# UNITED STATES PATENT AND TRADEMARK OFFICE

<b>Office Action Summary</b>	Application No. 10/657,343	Applicant(s) CHEN ET AL.	
	Examiner Felix O. Figueroa	Art Unit 2833

## **DETAILED ACTION**

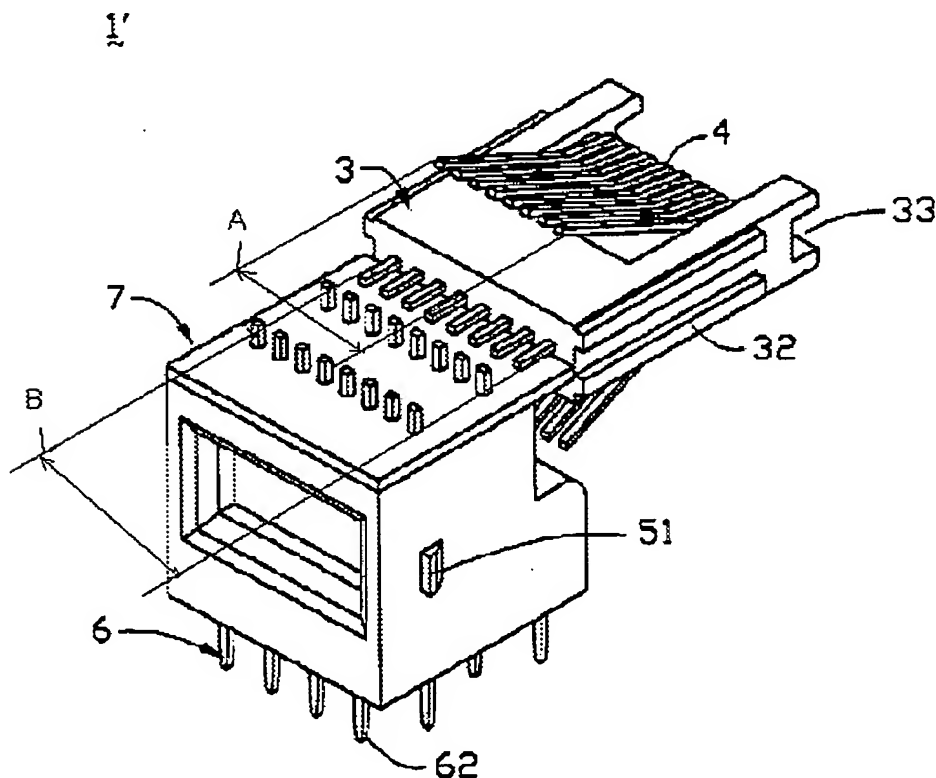
In response to Applicant's arguments regarding claim 6, please note that the overall space occupied by the first portion (A, as shown above) is smaller than that occupied by the second portions (B). Thus, the spacing between the second portions is greater than that of between the first portions.
